MODIFICATION INSTRUCTIONS

***Kodak X-Omat 2000* PROCESSOR**

Modification No. 3

Purpose: To install an EMI FILTER COVER for safety and GROMMETS to prevent a short circuit.

H172_1067HCA
H172_1067HC

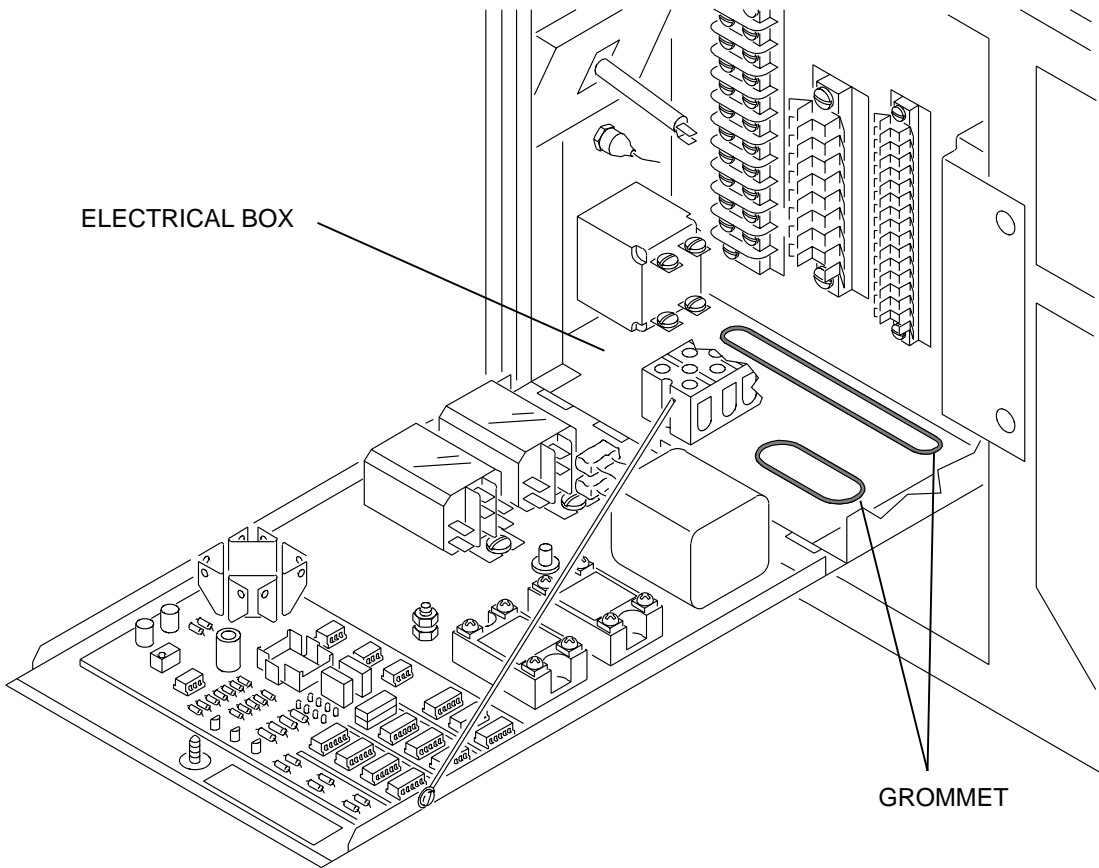
If there are 2 STUDS above the EMI FILTER	If there are no STUDS above the EMI FILTER
Install the new EMI FILTER COVER onto 2 STUDS using the 2 new WASHERS, 2 new LOCK WASHERS, and 2 new NUTS.	Install the EMI FILTER COVER onto the MOUNTING STUD for the EMI FILTER. <ul style="list-style-type: none">a. Obtain adhesive tape from the customer. Apply it to the EMI FILTER COVER.b. Make a 4.8mm (0.19 in.) hole in the EMI FILTER COVER.c. Remove the existing WASHER, LOCK WASHER, and NUT.d. Rotate and install the new EMI FILTER COVER.

- [5] Locate the 2 holes in the bottom of the ELECTRICAL BOX.
- [6] Cut the new GROMMET to the correct size for each hole.
- [7] Install the new GROMMET.
